Application for Site Plan Review - LAKE SHORE VILLAGE PH 3 Amendment

THE FOLLOWING BUILDINGS ARE PROPOSED: THE PROPOSED AMENDED SITE
PLAN WILL ADD (4) FOUR ONE BEDROOM APARTMENT UNITS
AND MOVE THE BUSINESS/FITNESS CENTER 30 FEET TO
ALLOW FOR FUTURE EXPANSION OF THE BUILDING, SEE LETTER
ATTACHED.

AMENDED SITE PLAN FOR LAKESHORE VILLAGE APARTMENTS PHASE 3

BUILDING MODIFICATION FOR SITE PLAN APPROVAL ADD 4 ONE BEDROOM UNITS TO BUILDING #22

BUILDING SECOND FLOOR PLAN

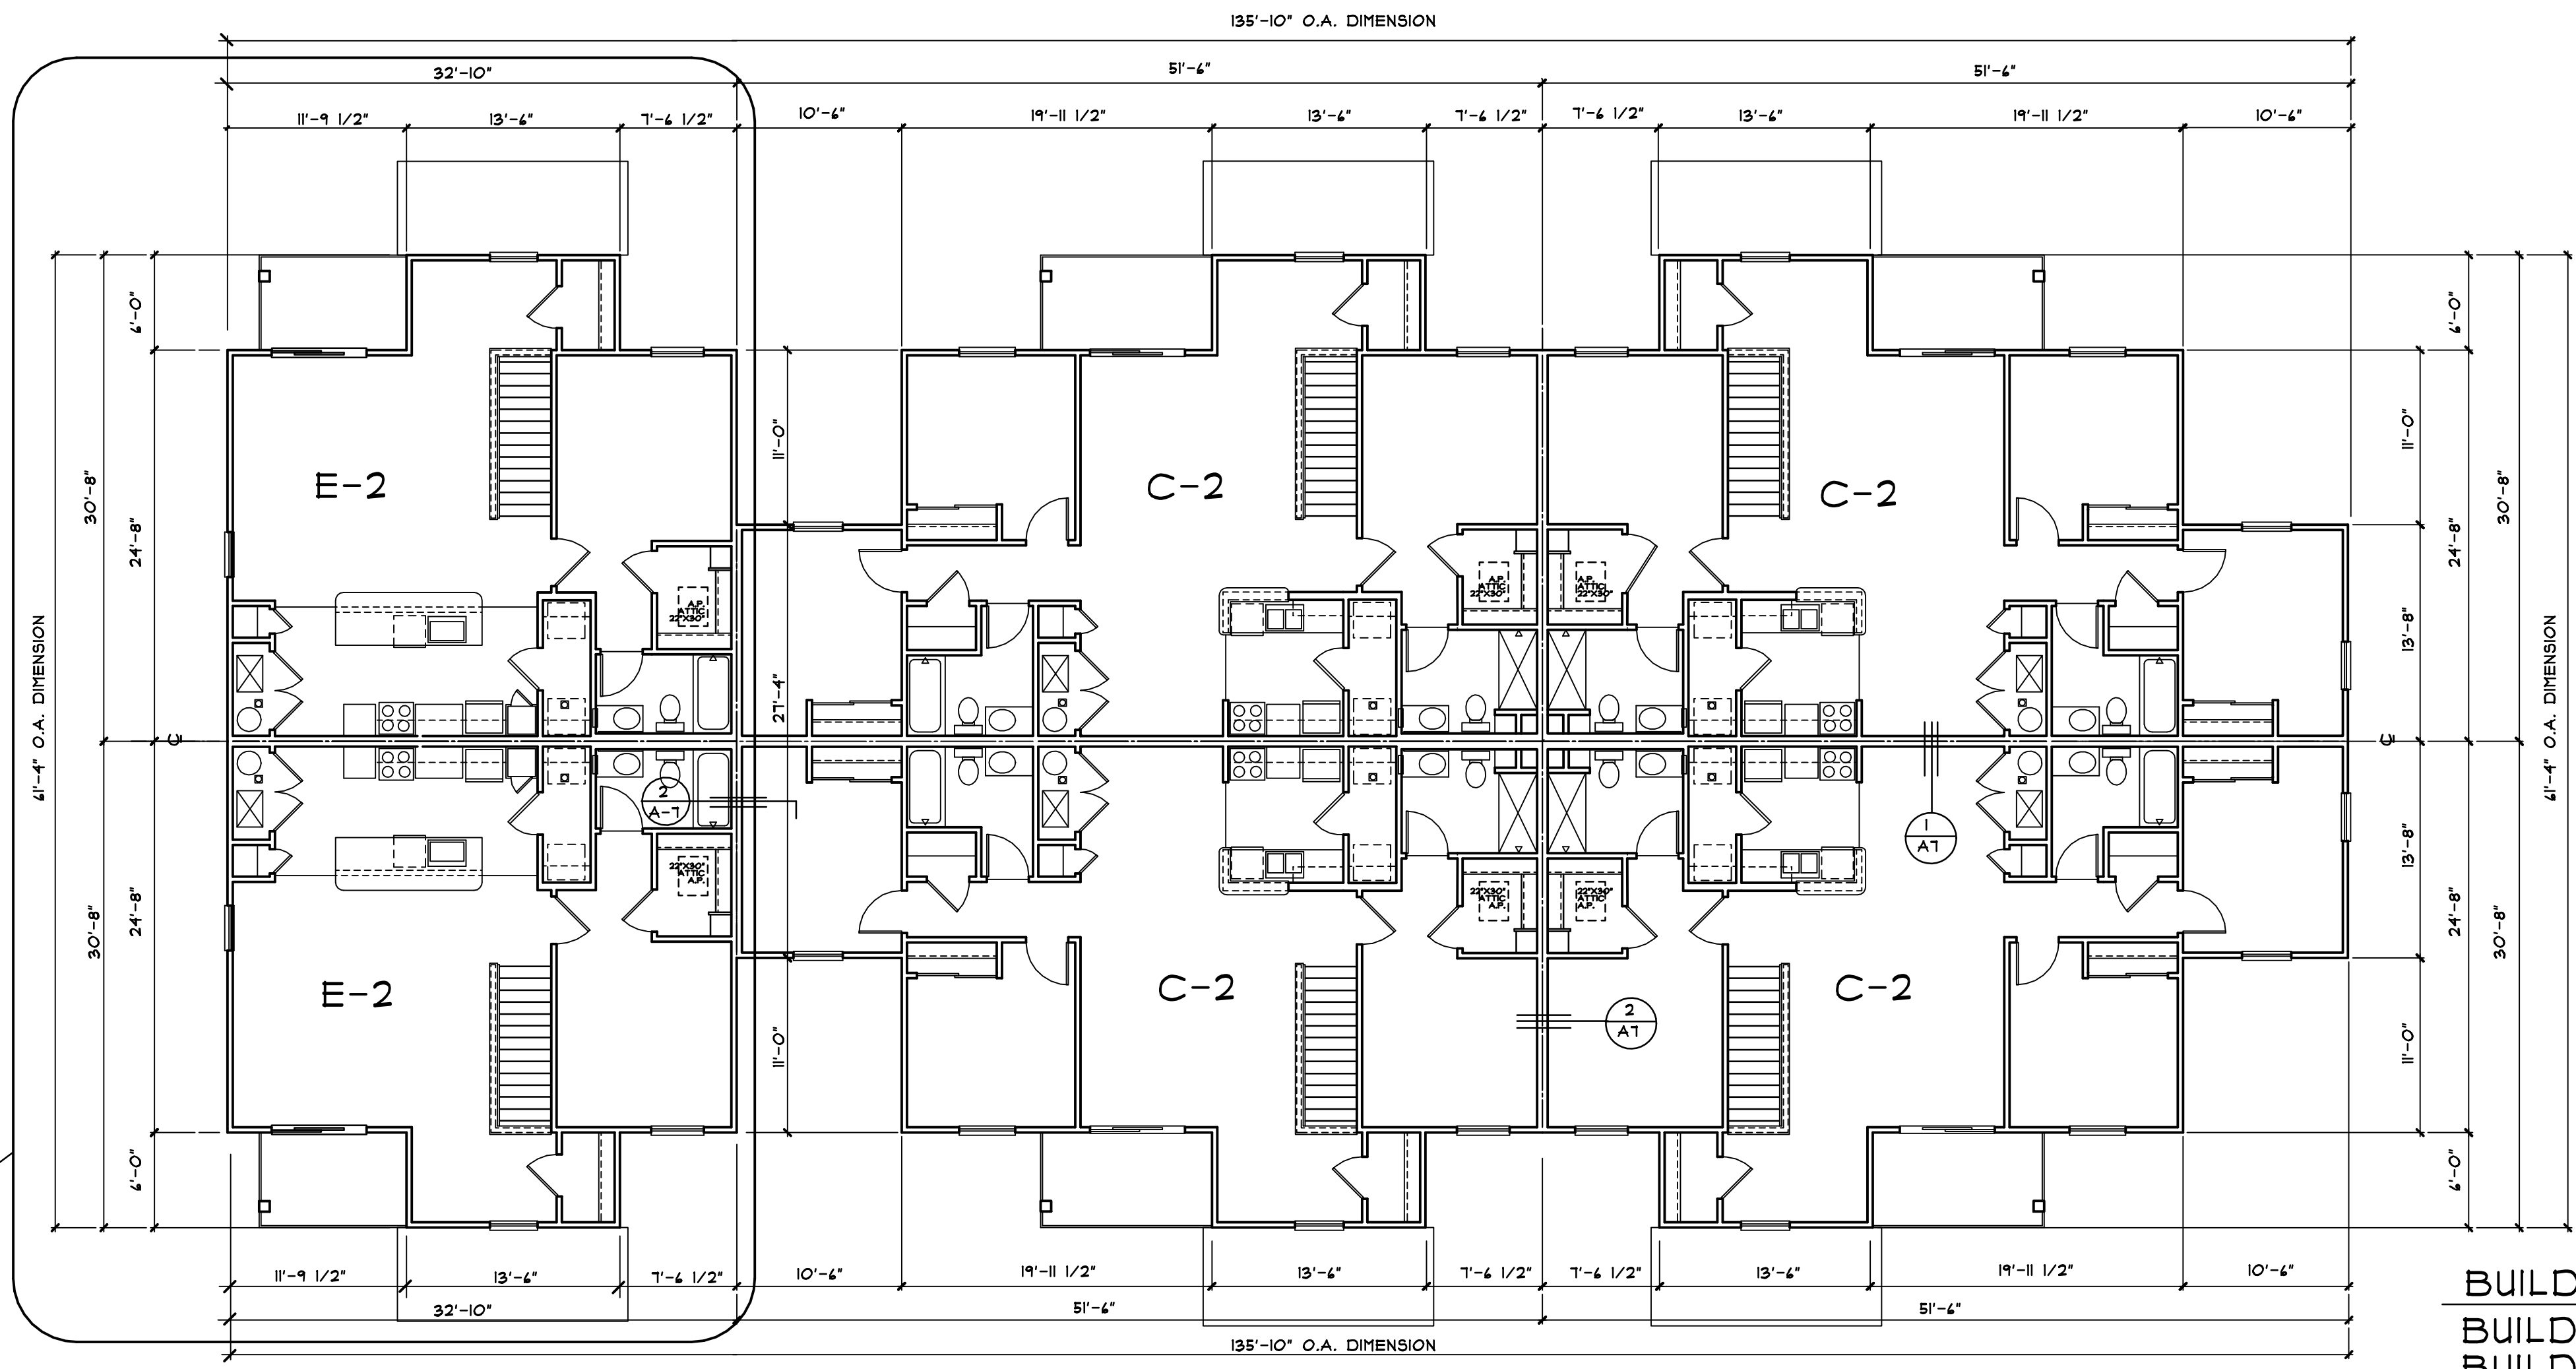
BUILDING MODIFICATION FOR SITE PLAN APPROVAL
 ADD 4 ONE BEDROOM UNITS TO BUILDING #22
